Technical Service Bulletin: tsb100641

New Combination Oil Pressure and Temperature Sensor Adapter

Table 1, Combination Oil Pressure and Temperature Sensor and Adapter

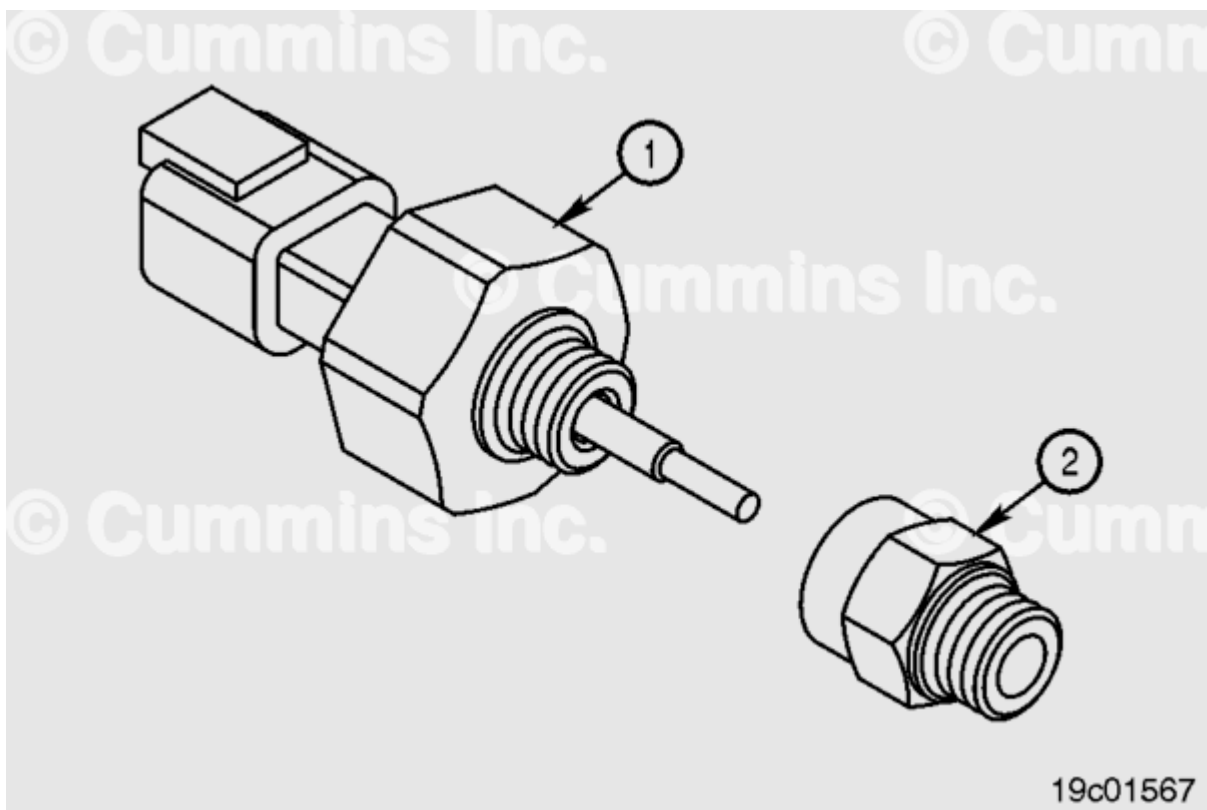
This Technical Service Bulletin announces the release of a new combination oil pressure and temperature sensor adapter, Part Number 4918864. The combination oil pressure and temperature sensor adapter is intended for use on the ISX with CM570 and the QSX with CM570 engine applications, in conjunction with the combination oil pressure and temperature sensor, Part Number 4921475.

When installing the combination oil pressure and temperature sensor adapter, be sure the adapter has the o-ring fitted and torque the adapter to 14 n·m [124 in-lb]. Install the combination oil pressure and temperature sensor onto the adapter and torque to 14 n·m [124 in-lb].
